**ADDENDUM NO. 2
July 6, 2023**

**Taxiway A Reconstruction – Phase 3
Duluth International Airport (DLH)
Duluth, Minnesota
City of Duluth No. 23-4409
AIP No. 3-27-0024-074-2022
SP No. A6901-205
SEH No. DULAI 168804**

From: Short Elliott Hendrickson Inc.
3535 Vadnais Center Drive
St. Paul, MN 55110-3507
651.490.2000

SHEET TITLE
STATEMENT OF ESTIMATED QUANTITIES - SCHEDULE B

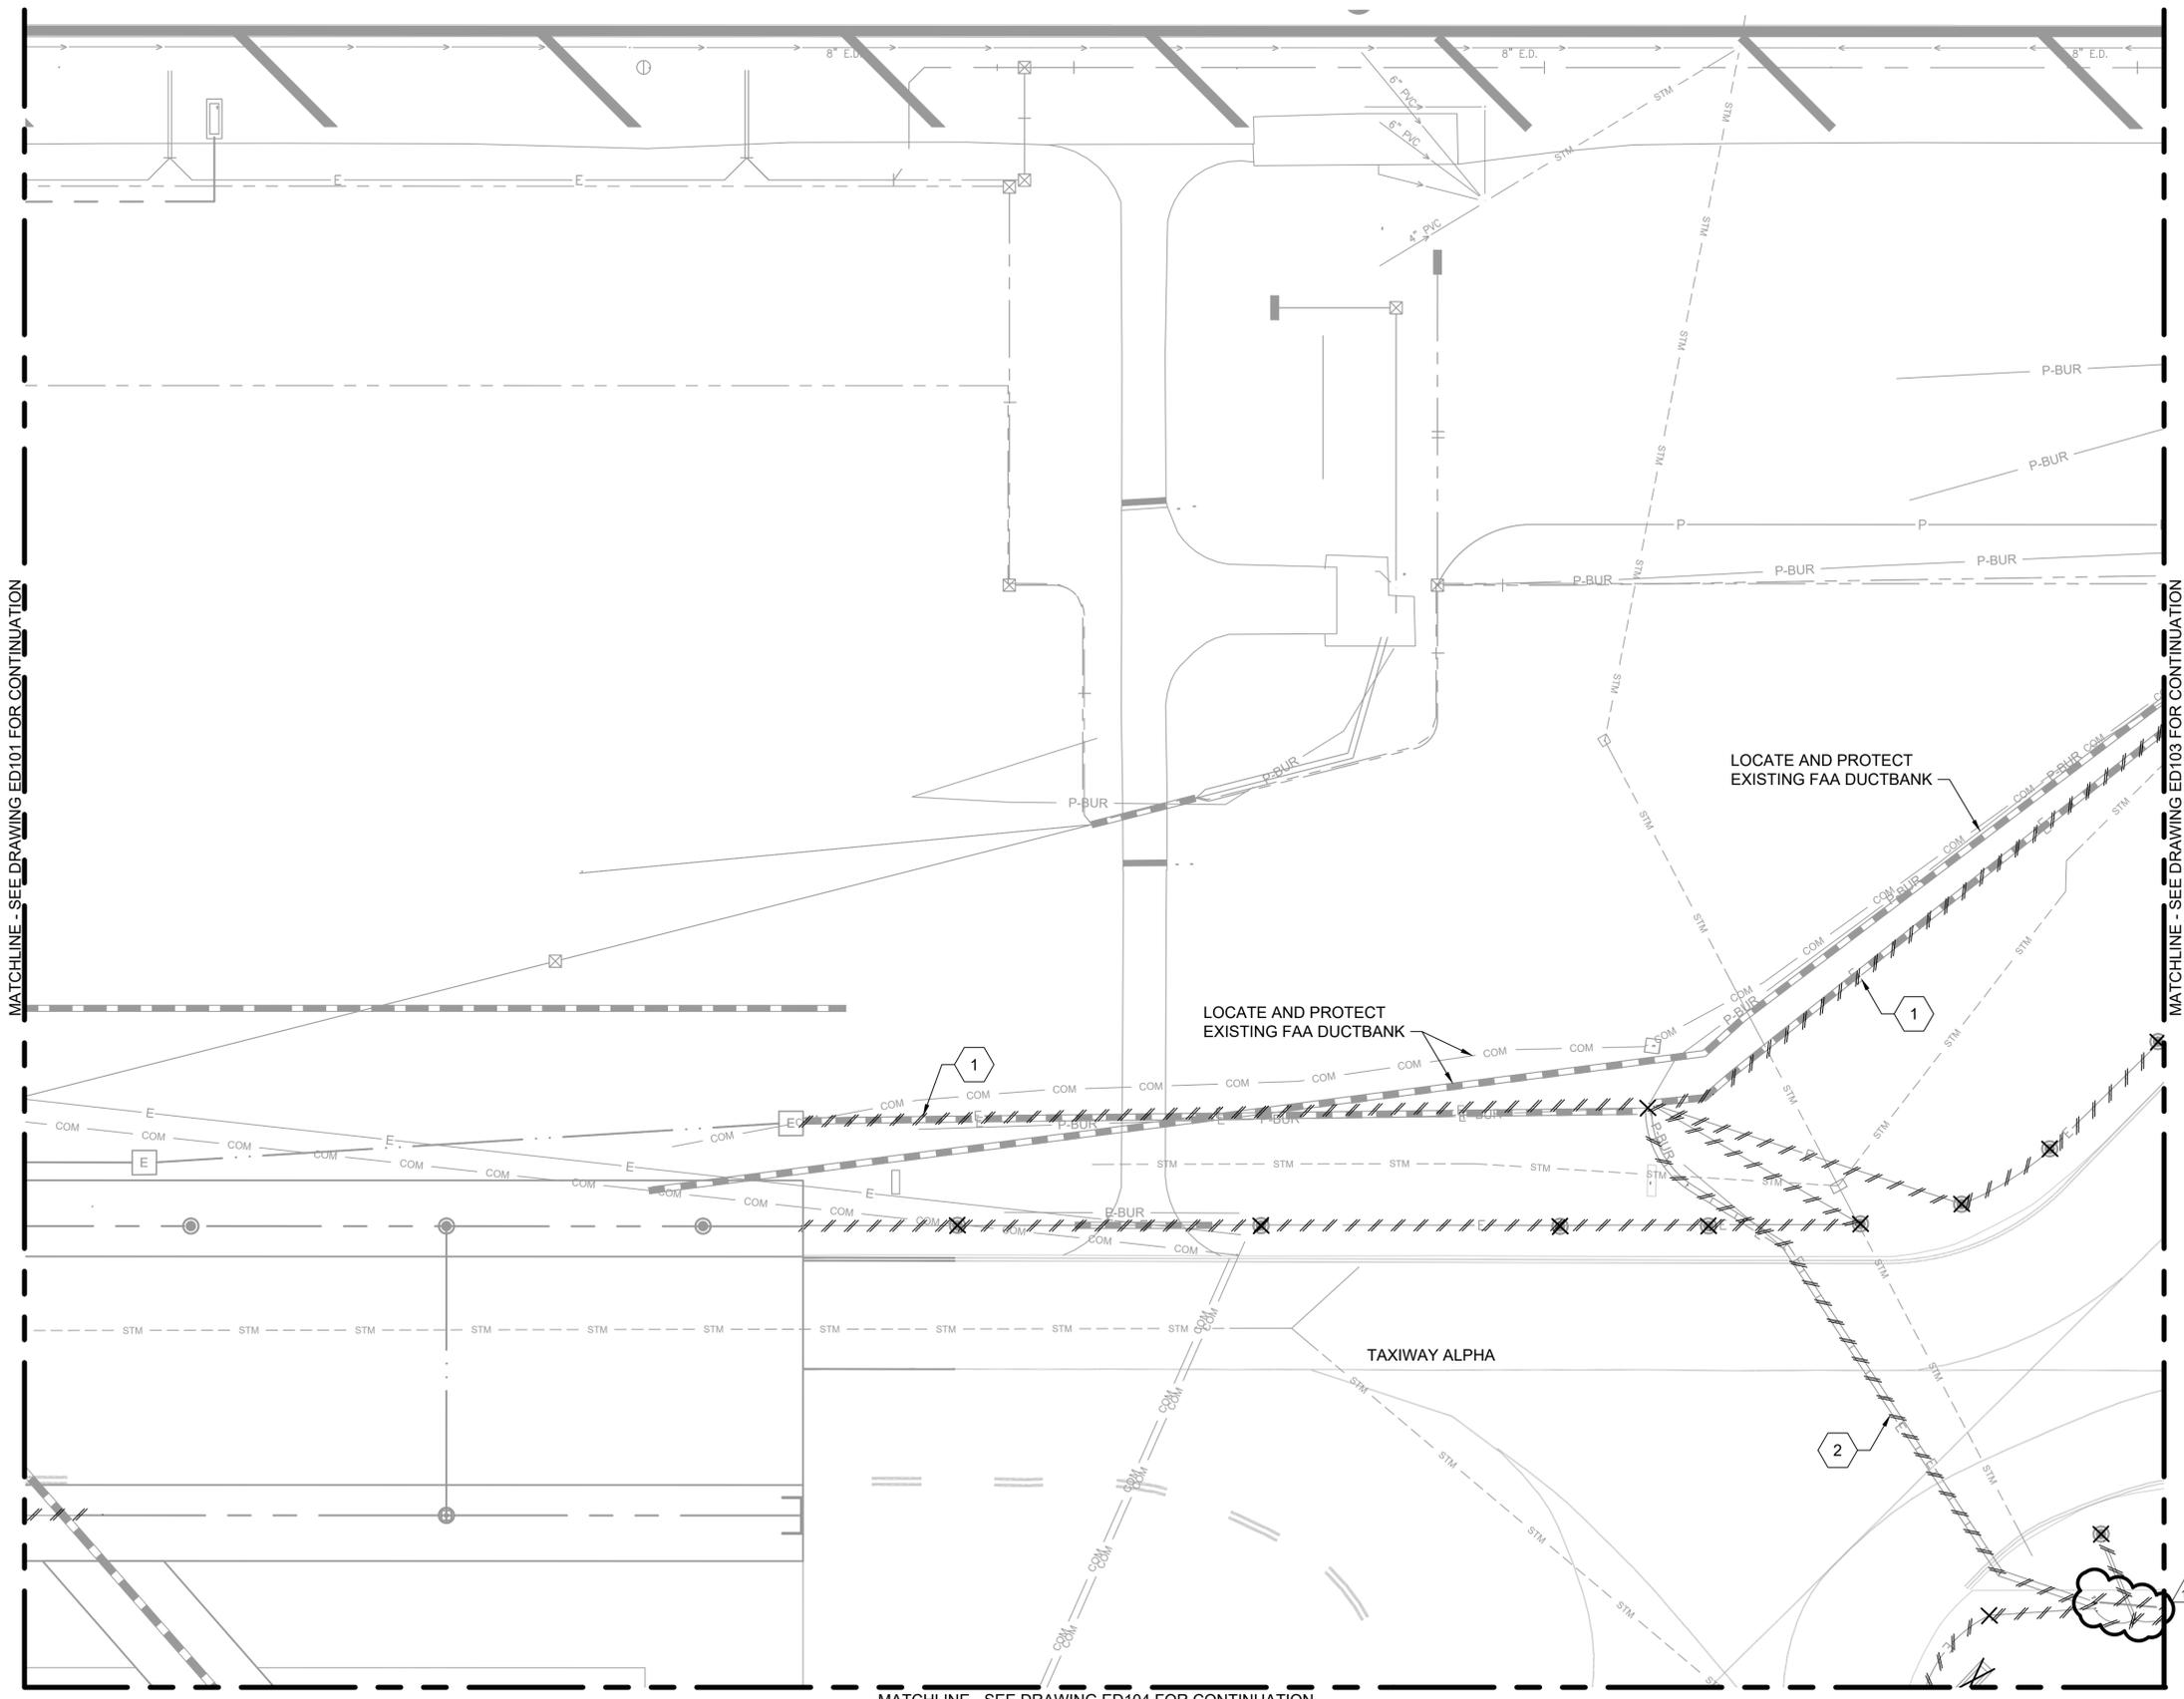
22. Question – What are the sizes of existing storm sewer pipe proposed to be removed?
 - a. SEQ Notes have been added to sheets G5.03 and G5.04 to better identify the size of existing storm sewer pipe to be removed with Items 54 and 119.

SHEET
ED102

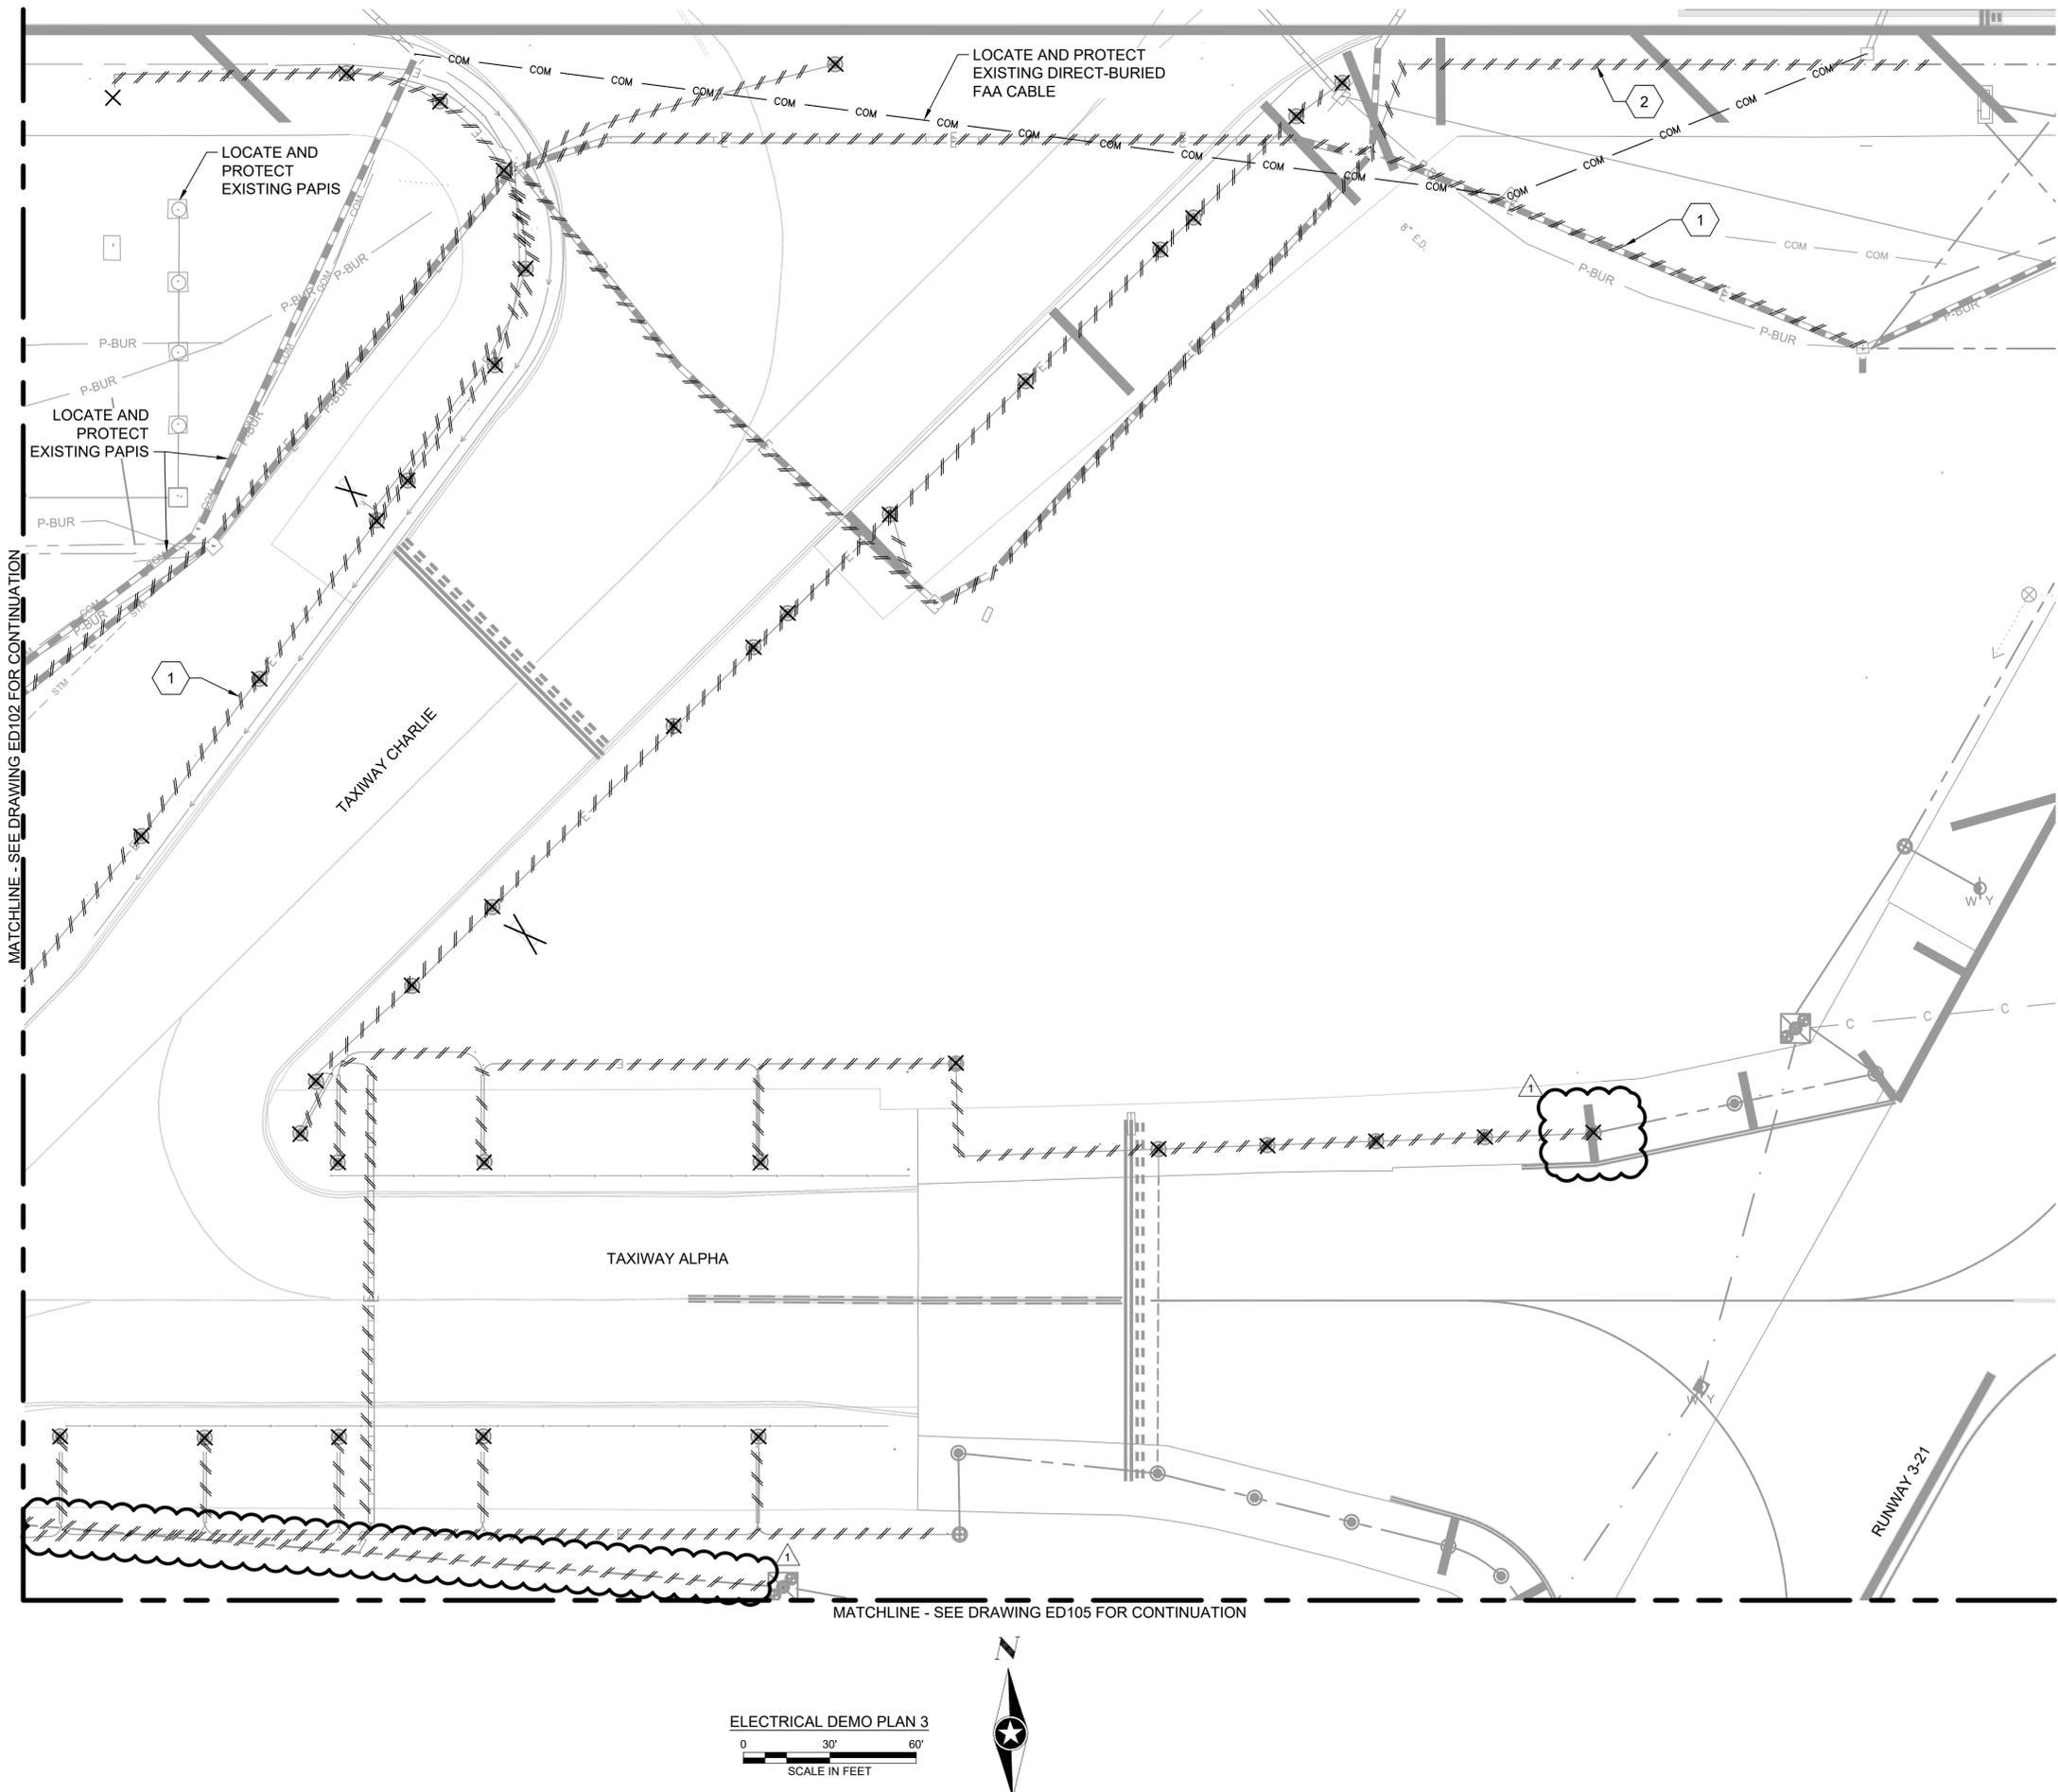
9. Drawing ED102 Electrical Demo Plan 2 – Additional electrical demolition reflected under proposed airfield pavement. DELETE in its entirety and REPLACE with the attached revised drawing.

SHEET
ED103

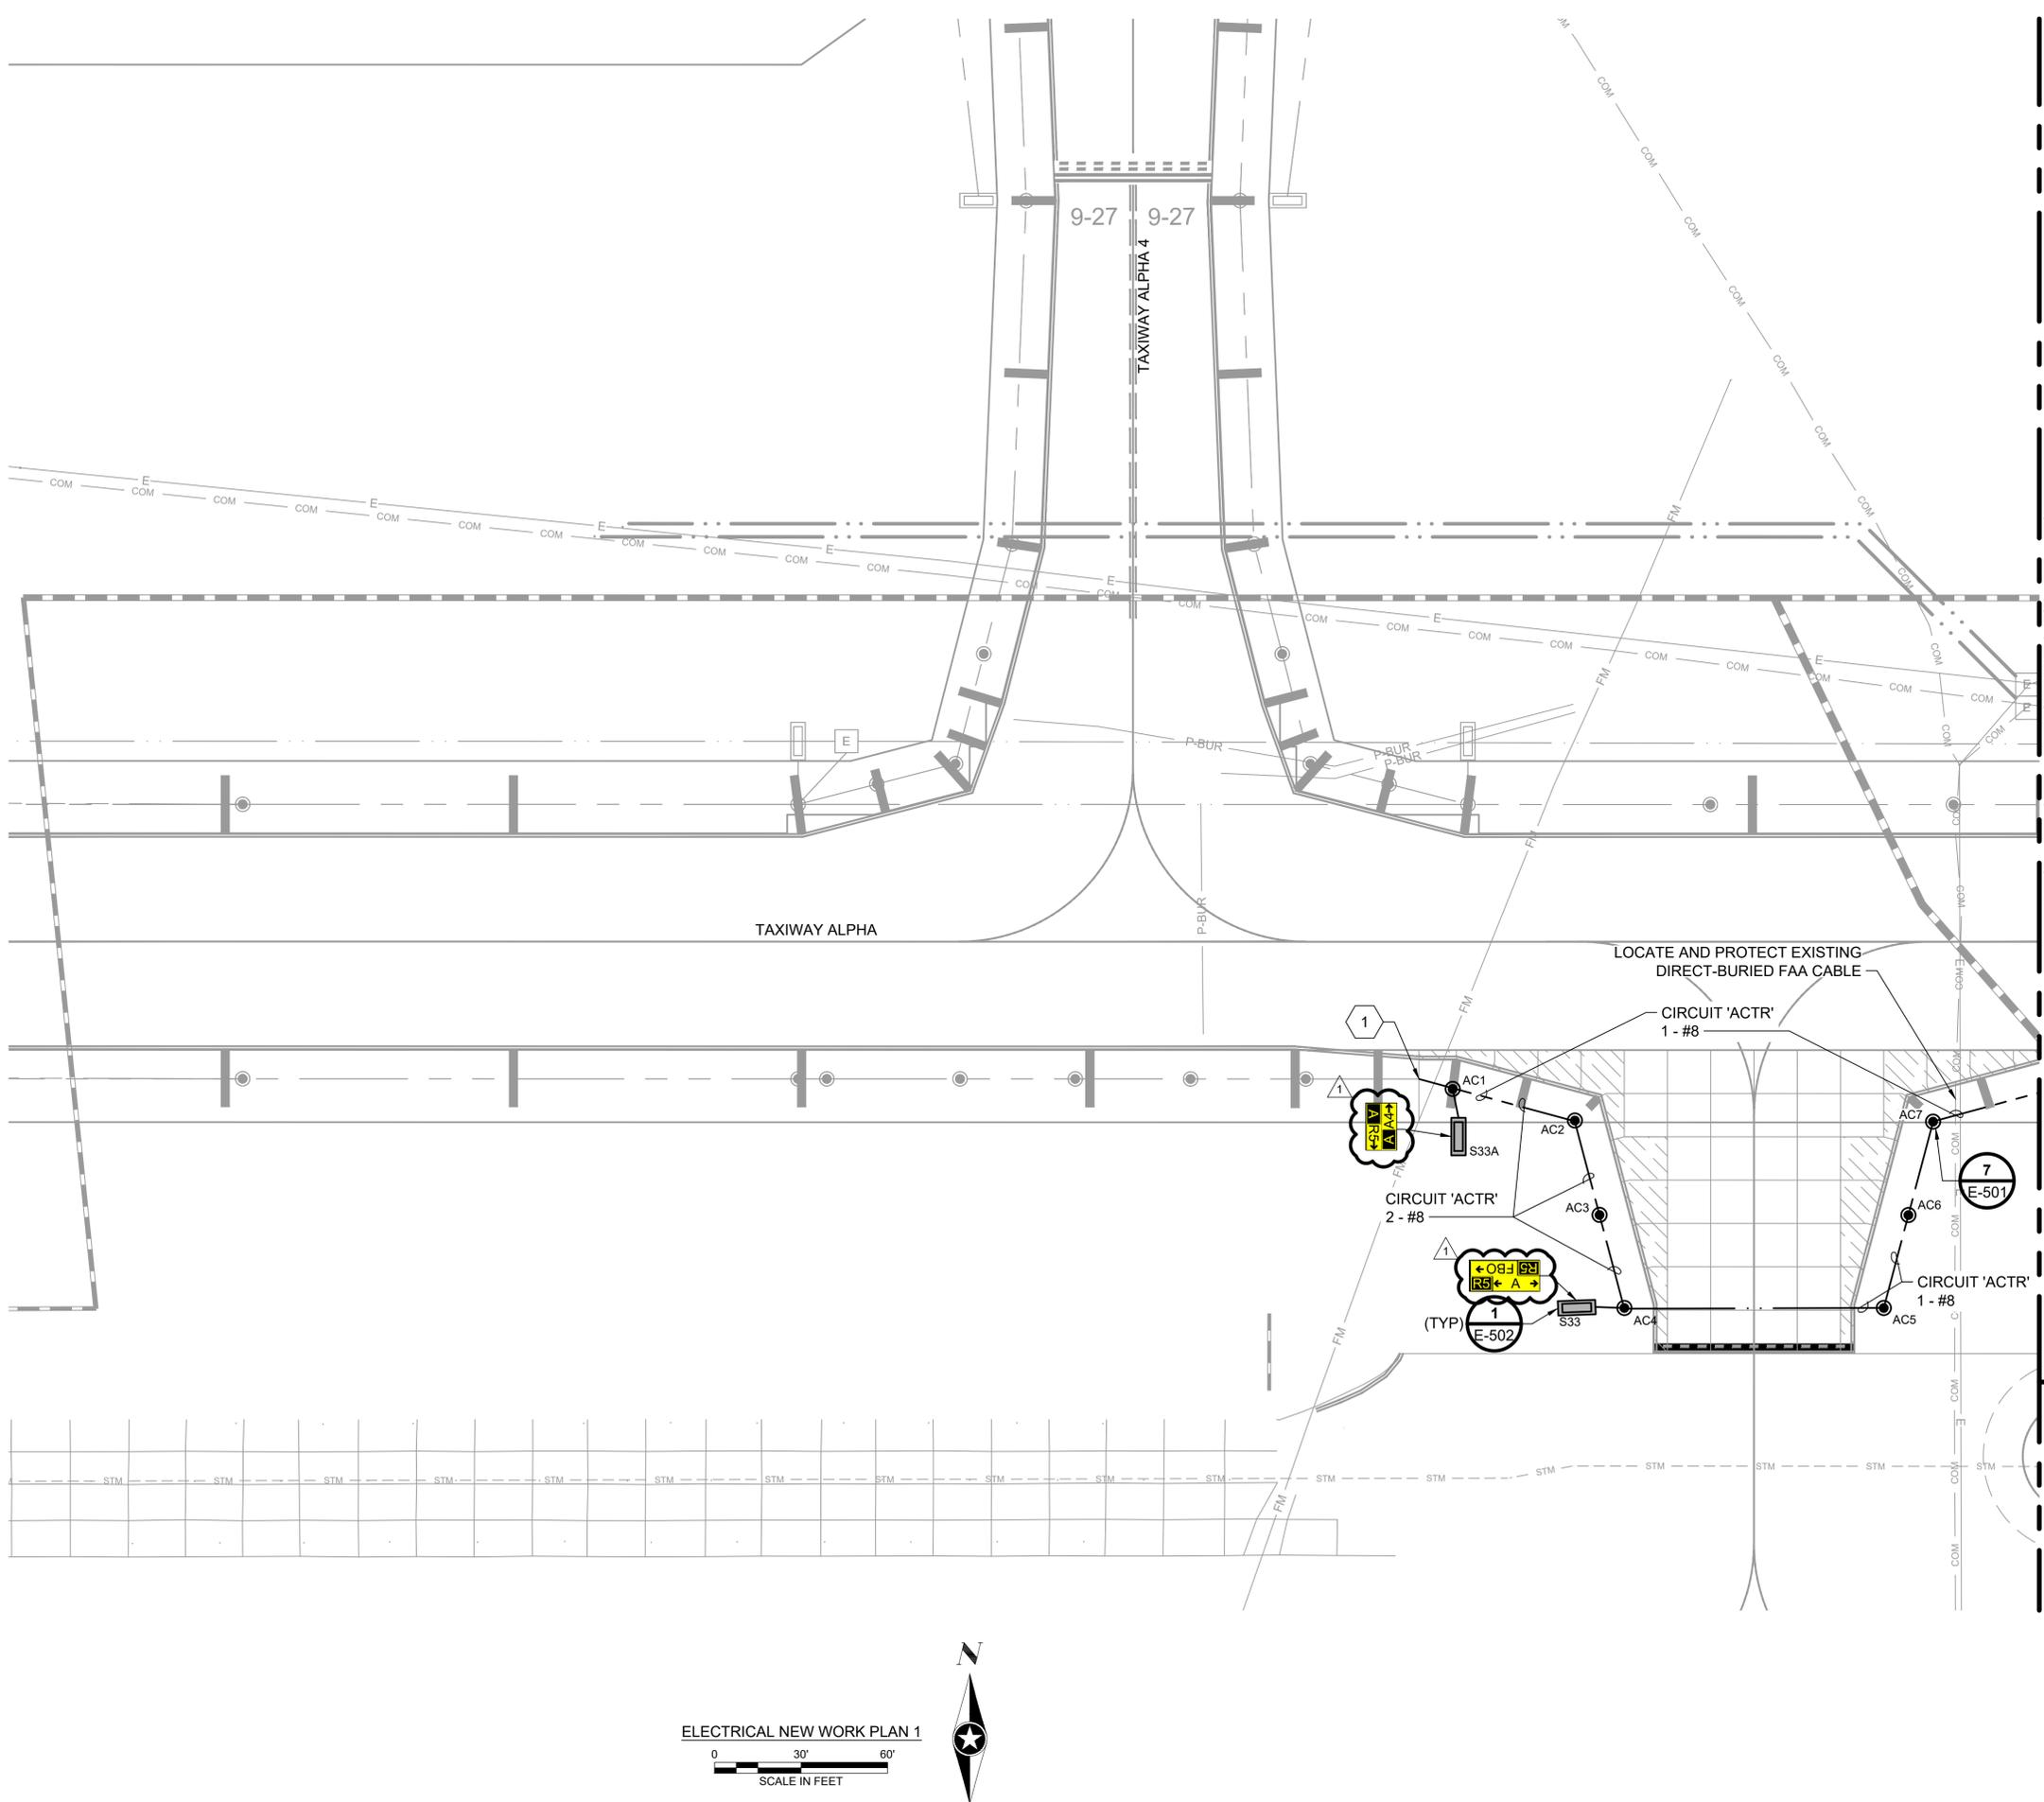
10. Drawing ED103 Electrical Demo Plan 3 – Additional electrical demolition reflected under proposed airfield pavement, and demolition of additional light fixture reflected in plan. DELETE in its entirety and REPLACE with the attached revised drawing.
